PRELIMINARY PLAT #00022

VAVRINA MEADOWS
 NE 16TH STREET
 LINCOLN, NE

Subject: Vavrina Meadows 1st Addition - CUP/Special Permit, Use Permit & Preliminary Plat

SITE PLAN

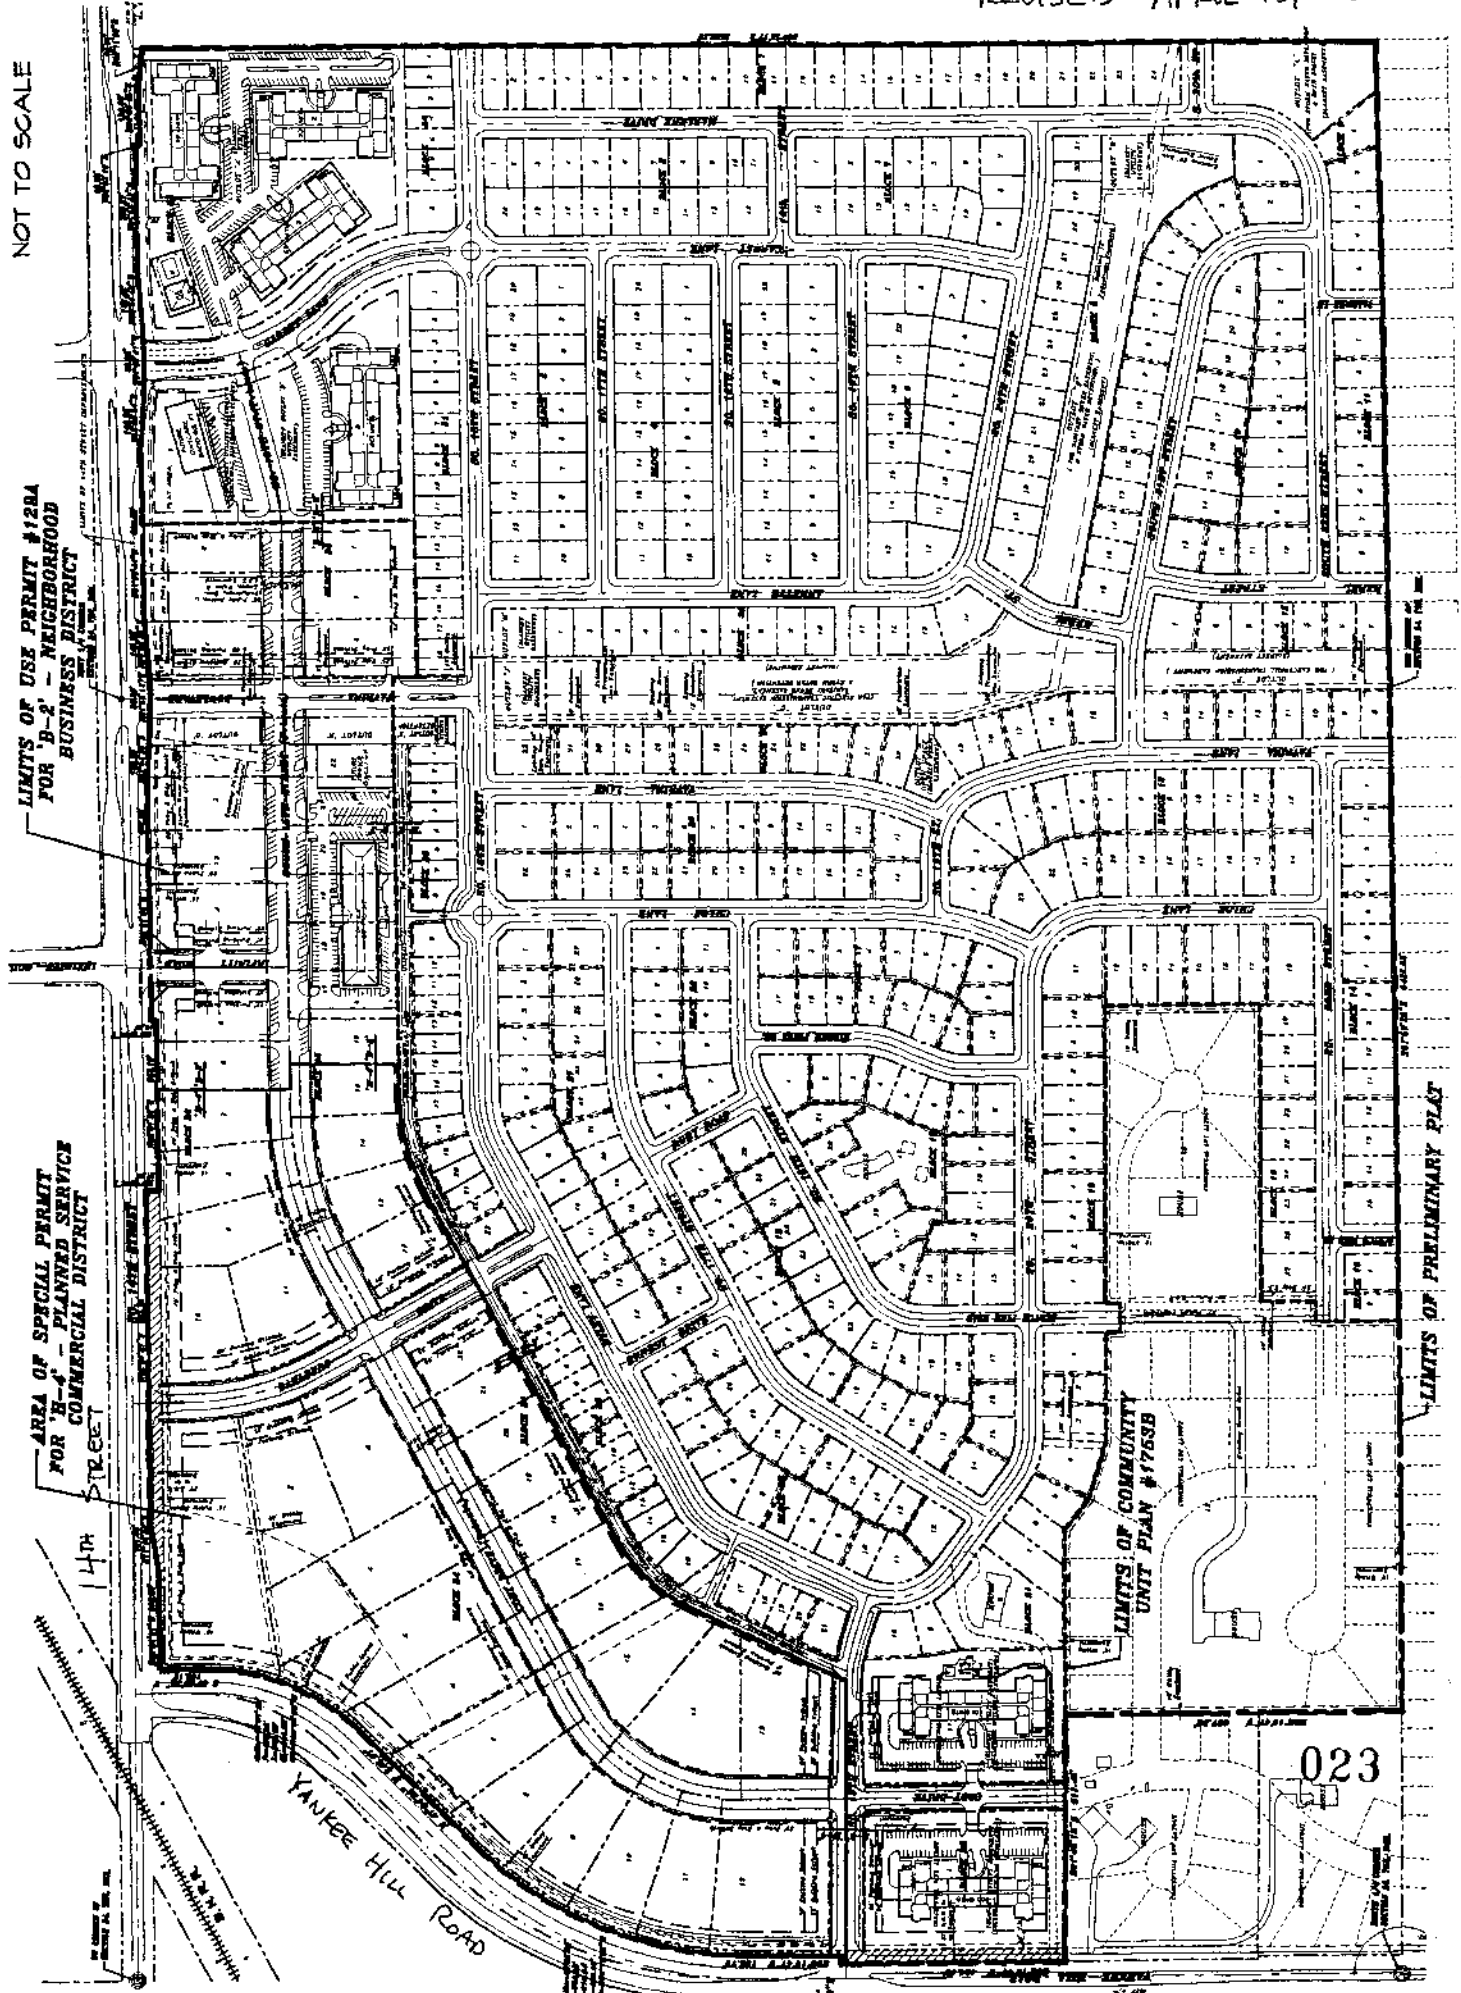
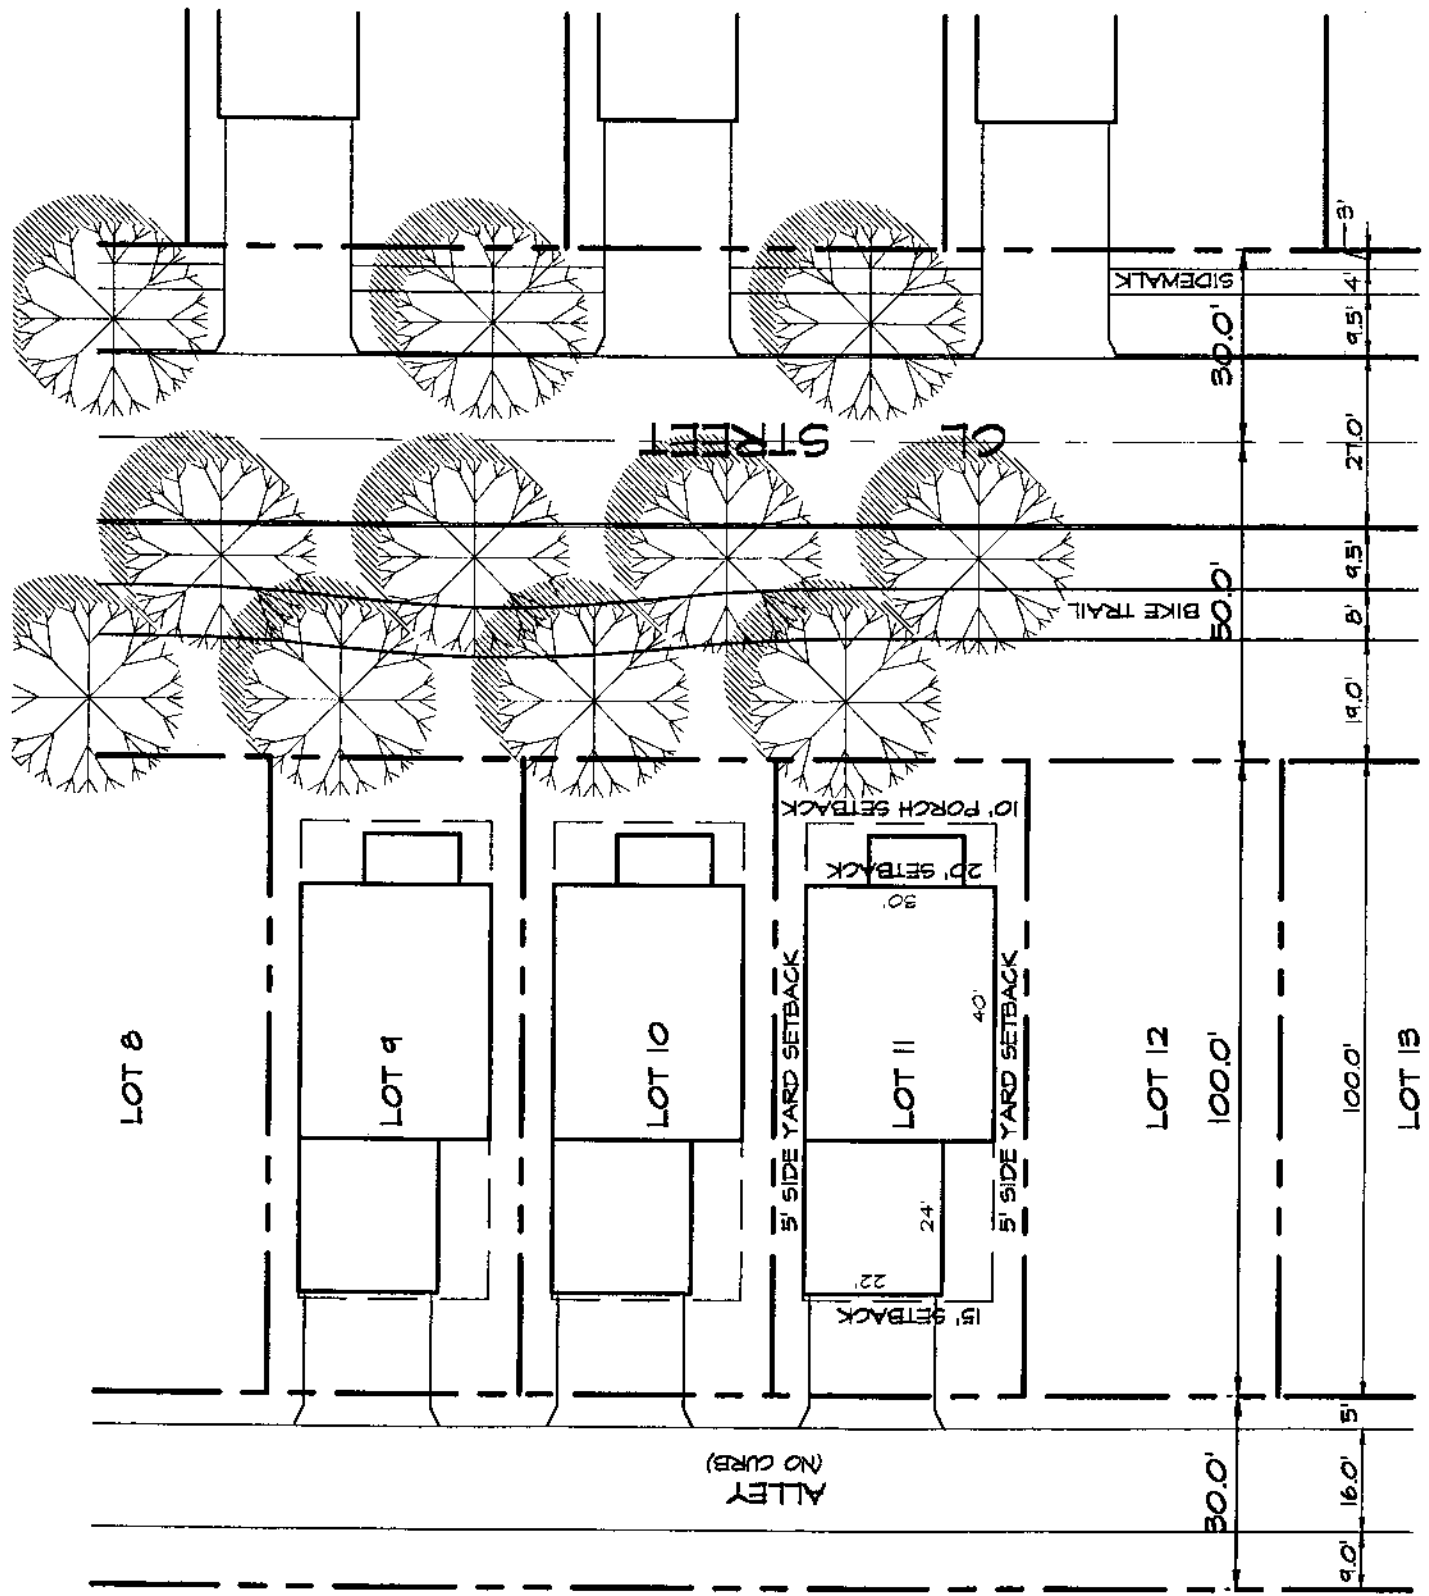
The proposed grading plan for Vavrina Meadows 1st Addition submitted as an amendment is unsatisfactory. The proposed detention does not stay within the limits of the proposed easement for the detention. The plan and calculations show flooding over and east of South 15th Street. The detention needs to be contained within an easement and must not flood any portion of the street system. The plan shows flooding of the dedicated right-of-way and parallel easement along S. 14th Street. The grading of the buildable area of lots and minimum building elevations should be identified to be above the 100 year detention and above an identified overflow elevation.

1. Water - No sizes are shown for the public mains in the residential portion of this plat. Per design standards, a 12" main is required at approximately the ½ mile line north/south and east/west through a section.

2. Sanitary Sewer - No outlet is shown for the sewer in Dahlberg Drive. The grade in 15th Street is opposite of street grades. The sewer will need to be built to the trunk sewer west of this plat. Sufficient depth is not available to build the sewer as shown.

Sewer needs to be shown to the east line of this plat in Scotch Pines Pass.

The existing and proposed sewer in the vicinity of 16th and Vavrina Boulevard is not accurately shown.

3. Drainage and Grading - The drainage study and grading plan is unsatisfactory and must be revised. No swales are shown downstream from sumps. No calculations are provided to verify swale capacities shown in sumps. Five year designs are shown downstream of sumps. The ultimate grading of 14th and Yankee Hill Road are not shown. Detention is shown into the right-of-way. Detention shown will flood lots and the street system. Design standard access, bottom slopes, hardened low flow channels, etc. are not shown. Detention calculations do not meet submission requirements. Culvert calculations must be shown for the 36" culvert inlet in Block 20. More detailed information is required concerning the grading of the detention. The flow line information in the calculations do not match contours.

The grading shown and the calculations for detention show flooding 15th Street and existing platted lots south of Vavrina east of 14th. This is unsatisfactory.

4. Street System - The existing traffic circle at 16th and Garrett is not designed adequately to accommodate public school buses. The 16th and Linda Lane circle is shown with the same design. The design must be revised and the existing circle rebuilt to handle design traffic and existing design standards.

The traffic study must be revised to the satisfaction of Public Works. The South 18th Street and Scotch Pines Pass intersection is a 4-way intersection of two relatively long and potentially high volume local streets. Either a redesign of the street system to eliminate the 4-way intersection or a traffic calming measure such as a traffic circle should be designed at this intersection.

The private driveway lane for Block 21 and 24 needs more detail. No grade is given and no typical cross-section is shown so there is no design to evaluate and comment upon.

The open ditches along 15th Street and the size of the lots will require numerous driveway culverts. This design should be reconsidered. An open drainage ditch through a median would be much easier to operate and maintain rather than an open ditch with multiple closely spaced culverts. The design of this ditch needs to be analyzed assuming the multiple culverts if that is the desired cross-section.

- 1) Traffic circle islands, boulevards, and right-of-way area along trail should be maintained by developer or future homeowners association. "Street trees" between trail and curb will be maintained by the City. Plantings between trail and residences should be maintained by developer or future homeowners association.

- 2) Trail location at Western end of Vavrina Boulevard needs to be a minimum of 8' from curb for snow removal. Any easements for trail along S. 19th St. need to be identified.

- 3) Please submit an outdoor recreation plan for the proposed multi-family residential area in the southeastern area of the site.
- 4) Number of street trees proposed for S. 16th St. (189 Red Sunset Maples) from S. 19th St. to Vavrina Blvd. needs to be revised due to size of lots, proposed 10' wide bike trail, and the eventual mature size of the Red Maple. Staggered planting arrangements can only be done if street trees are located at least 5 feet away from trail and are spaced at 60' on center. Incorporation of evergreen trees on homeowner side of trail may be desirable for aesthetics and screening. Street tree schedule needs to be revised to show correct number based on this spacing requirement.

- 5) Street trees are shown to be planted on center medians for Garret Lane, Dahlberg Dr., and Vavrina Blvd. Traffic Engineering needs to review to determine if there are any traffic sight distance concerns.

- 6) Traffic roundabouts are shown at S. 16th and Linda Lane and S. 16th and Garret Lane. If these are to be landscaped, the developer must submit plans for review by Parks and Recreation and Traffic Engineering.

PROPOSED _____	SIMILAR _____
LINDA LA	LINDALE, LINDEN, LONDON

The concerns of the Police Department regarding this development are that blocks 1, 22, and 23 appear to be of a length beyond requirements by City Code.

- 1.1.4 Provide an alternate street name for Linda Lane. Provide a non-numbered street name for 15th and 16th, south of Dahlberg Drive. Provide a standard street name ending for "Scotch Pines Pass" such as Drive, Road, Street, Lane, etc.

- 1.1.5 Provide additional details on the plans regarding the design of the "roundabouts" to meet design standards.
- 1.1.6 Provide additional fire hydrants, if required, by the Fire Prevention review of Building and Safety.

- 1.1.7 Revise the sanitary sewer and water mains to the satisfaction of the Public Works and Utilities Department.
- 1.1.8 Revise the grading and drainage plan to the satisfaction of the Public Works and Utilities Department.

- 1.1.9 Clarify the lot lines and easements between Lot 28, Block 15 and Lot 10, Block 20. Note the 10 foot easement in Outlot F. Combine Outlots J and G or provide the purpose for Outlot J on the plan.

- 1.1.11 Revise the street tree plan and landscape plan to the satisfaction of the Parks and Recreation Dept. including landscaping proposed for the roundabouts.
